182186 -Priorsland Cherrywood SHD

**An Bord Pleanála Opinion Summary
Response**

Document Number: 182186-ABOSR-PL0

Appendix A DLRCC 'Preferred Option'

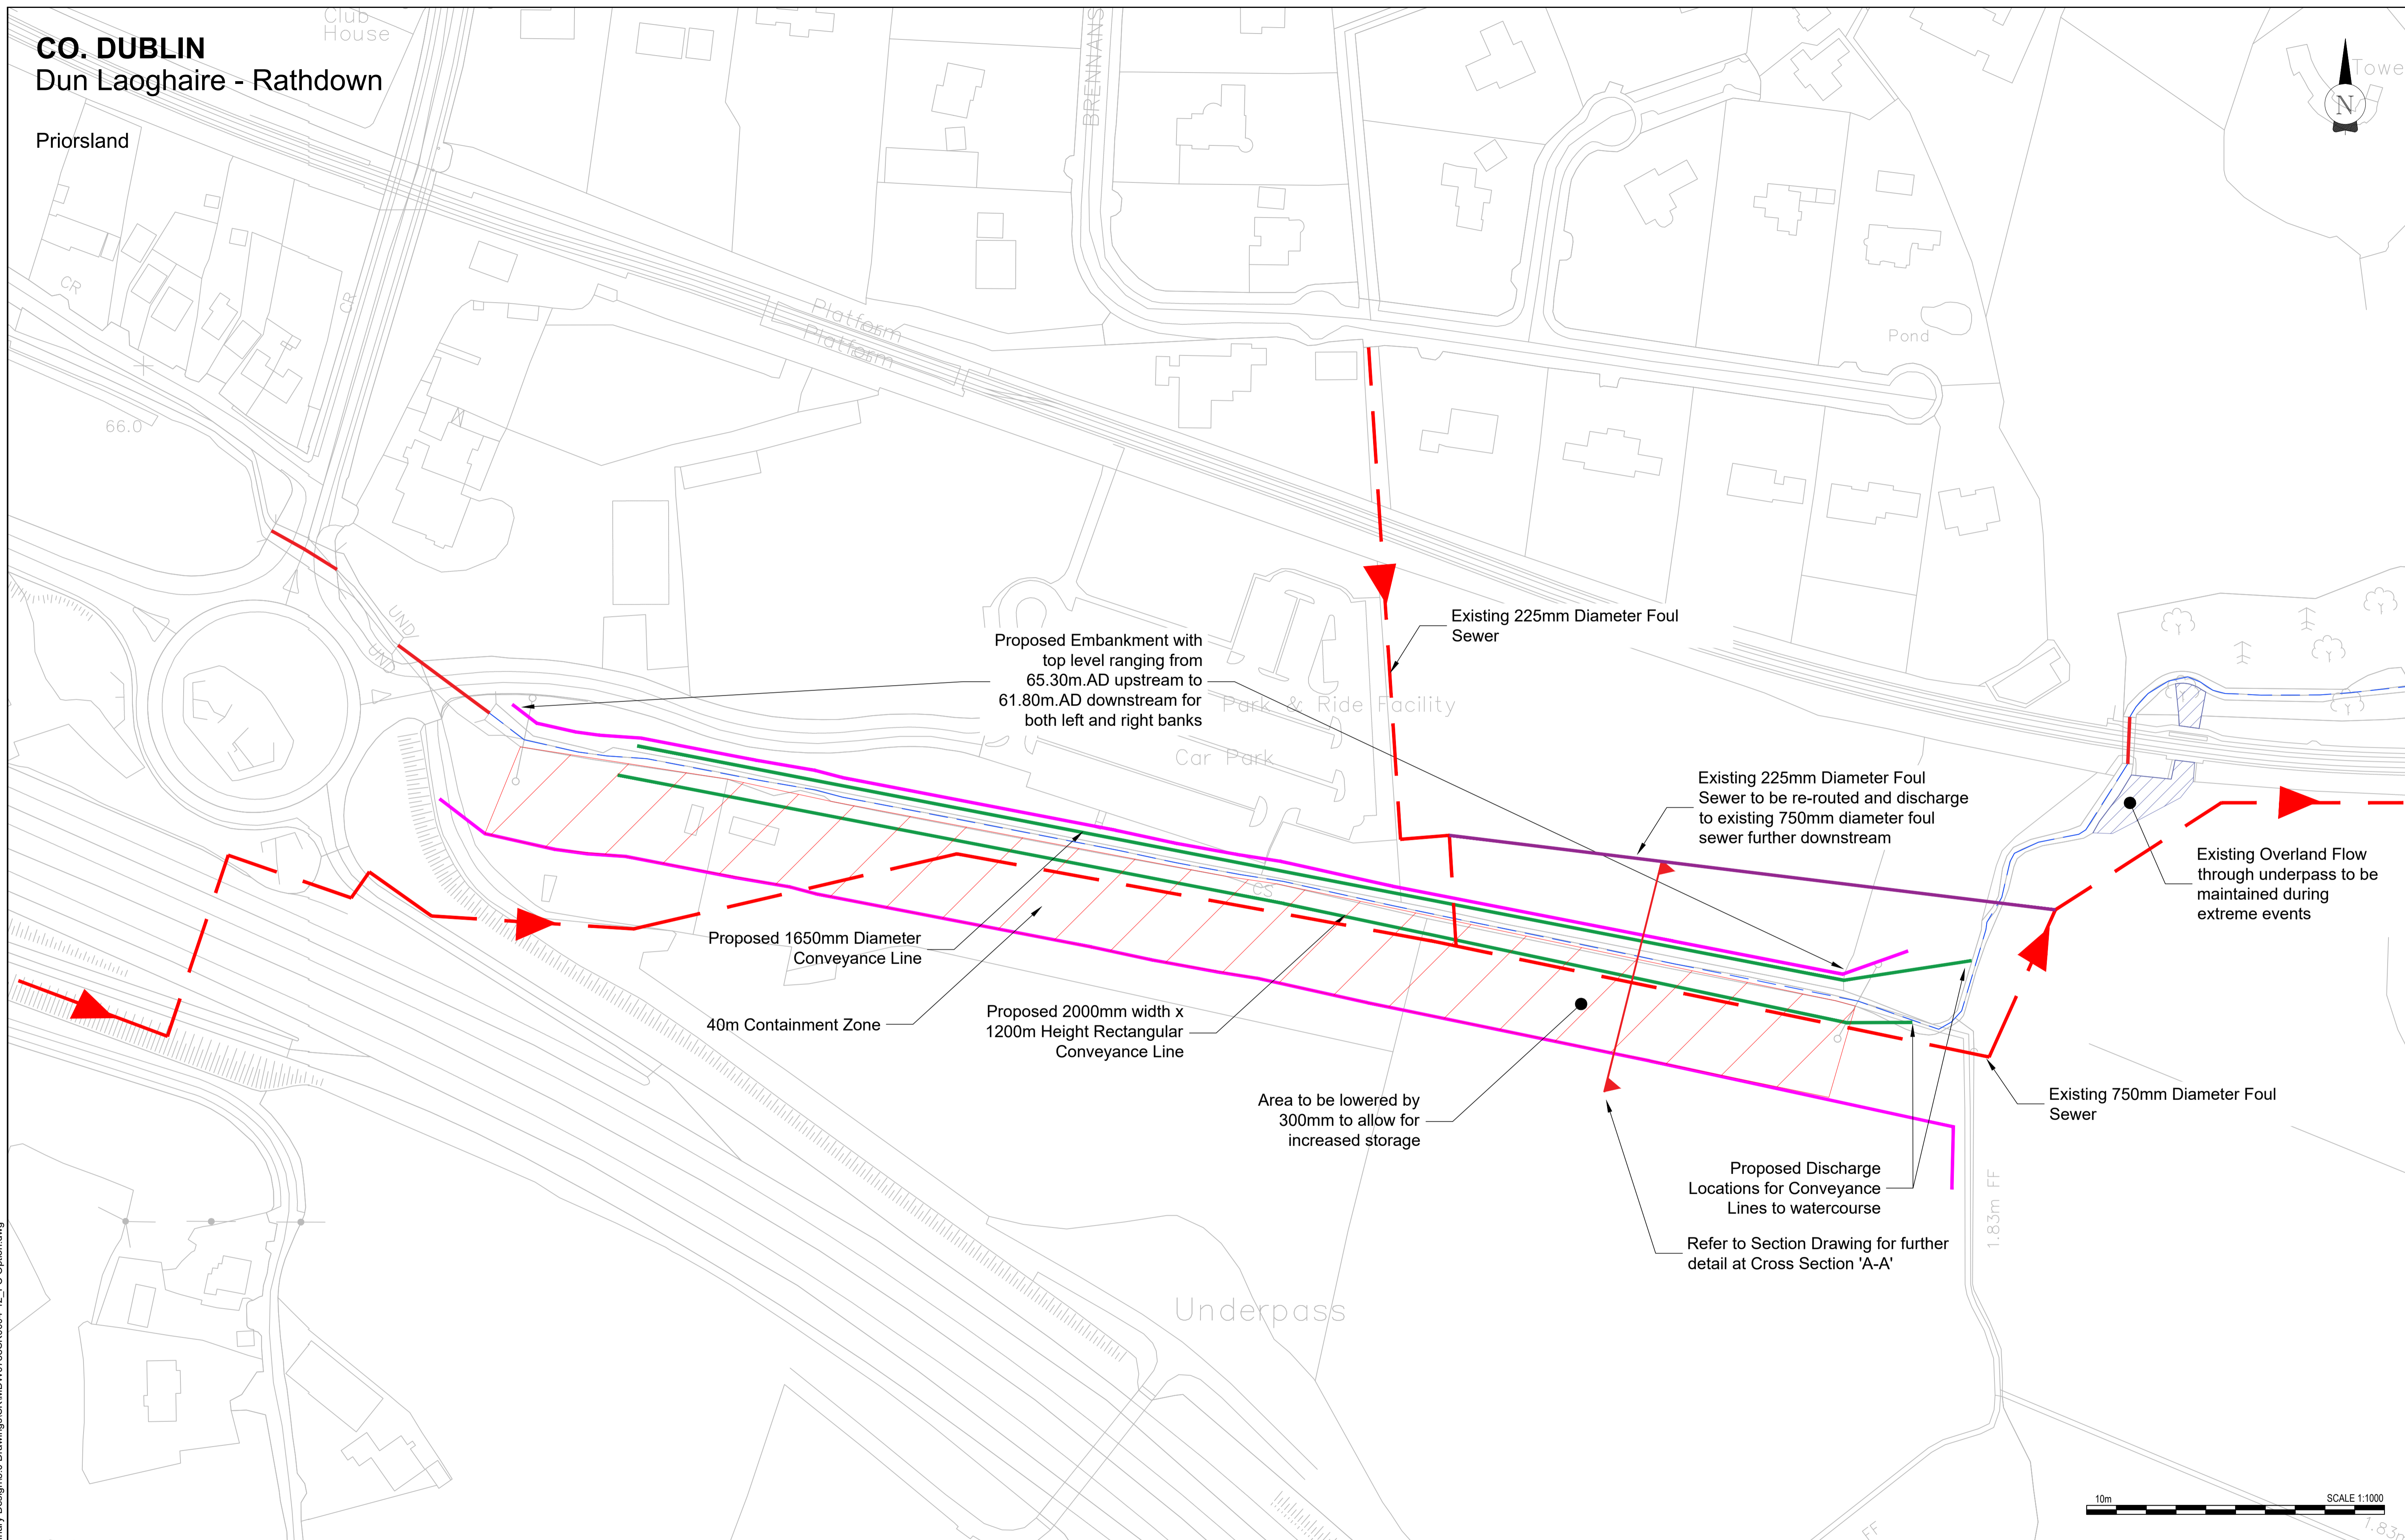
Ref No.	Page No.	ABP Comment	PUNCH Response
		<p>Flood Mitigation related DAPT conclusions:</p> <ul style="list-style-type: none"> DLRCC have carried out a feasibility assessment and have determined a preferred flood mitigation option to alleviate flooding in the Priorsland development area. The proposals as submitted are considered inconsistent with the requirements of the Planning Scheme and the DAPT will require that the applicant fully demonstrates in a further submission how their proposed design compares to DLRCC's preferred flood mitigation option and how their design mitigates flood risk not only for the subject development site but for the surrounding Priorsland development area and for the Common's Road area downstream. Notwithstanding the above, the DAPT consider proposals to discharge the extended flood relief culvert to a ditch as unacceptable and it is considered that further and detailed justification is also required from the applicant for the interim solution proposed in place of full completion of the northern food relief culvert. Notwithstanding the above, the DAPT consider proposals that omit flood containment on the norther side of the Carrickmines River as unacceptable and will require that flood containment on the northern side of the Carrickmines River, as detailed in the Planning 	<ul style="list-style-type: none"> It is noted that DLRCC commissioned Consulting Engineers RPS in 2018 to carry out a feasibility assessment and determine the most effective flood mitigation option to alleviate flooding in the Priorsland development area which forms part of the Cherrywood Strategic Development Zone. A total number of nine flood mitigation options were assessed and one option, deemed the preferred option, was recommended on the basis of providing the most favourable outcome. <p>Please note that this feasibility assessment has absolutely no statutory or planning status and so does not govern the Planning Scheme requirements.</p> <p>Following review of the outline RPS proposals by PUNCH, we note that the proposed works associated with the preferred option would contravene a number of key ecological/environmental requirements associated with the SDZ and the DLRCC Development Plan, which render this option completely unviable. Refer to SSFRA Section 3.7 for further details.</p> <p>The flood mitigation proposals as presented in this planning application and associated SSFRA are consistent with the requirements of the Planning Scheme, whereas the DLRCC 'preferred option' is demonstrably not compliant.</p> <ul style="list-style-type: none"> There are no proposals to “discharge the extended flood relief culvert to a ditch”. The proposals are to extend the

Ref No.	Page No.	ABP Comment	PUNCH Response
		<p>Scheme and progressed in DLRCC’s preferred flood mitigation option, is addressed in an amended design and revised SSFRA.</p> <ul style="list-style-type: none"> Refer to the conclusions and recommendations contained in the JBA report entitled “2020s1114 - Review of site-specific Flood Risk Assessment” in Appendix B. JBA conclude that the information provided under the SSFRA submitted is insufficient to determine that Flood Risk is appropriately addressed onsite and elsewhere through the provision of proposed mitigation measures for this development. JBA also conclude that as the site is within Flood Zone A and B. the Justification Test is required by the Planning Guidelines to be applied and satisfactorily passed and the lack of detail in the SSFRA submitted has not demonstrated that the conditions of the Justification Test has been met. The DAPT require that exceedance flows are addressed in a further submission. The DAPT require that full details of the proposed basement network are provided in a further submission. 	<p>flood relief culverts back into the Carrickmines Stream at downstream locations (entirely consistent with the CPS).</p> <ul style="list-style-type: none"> As demonstrated in the SSFRA protection to the lands to the north of Carrickmines Stream is granted by the existing topography. Please refer to Appendix A for drawing extracts from the DLRCC/RPS feasibility assessment. Please further note that the proposed introduction of raised bunds as proposed under DLRCC’s ‘preferred option’ would eliminate the entirety of the riparian habitat and preserved mature tree line (including mature Turkey Oaks) to the north of Carrickmines Stream. Furthermore, the dredging of the flood plain to the south would similarly destroy all riparian habitat to the south of Carrickmines Stream - all completely contrary to the environmental/ecological requirements of the CPS and other statutory authorities such as Inland Fisheries Ireland and National Parks and Wildlife Services. It is also noted that the introduction of discrete berms as flood protection in a flood plain, with residential development to the rear is absolutely not acceptable protection for such development under the requirements of “The Planning System & Flood Risk Management Guidelines”. Respectfully, the feasibility assessment commissioned by DLRCC seems to consider the hydraulic nature of the flood mitigation and does not consider the myriad other factors/issues that must be addressed in a holistic design solution. Please refer to the SSFRA, which provides sufficient detail and adequately addresses flood risk and the associated mitigation of flooding in accordance with the requirements
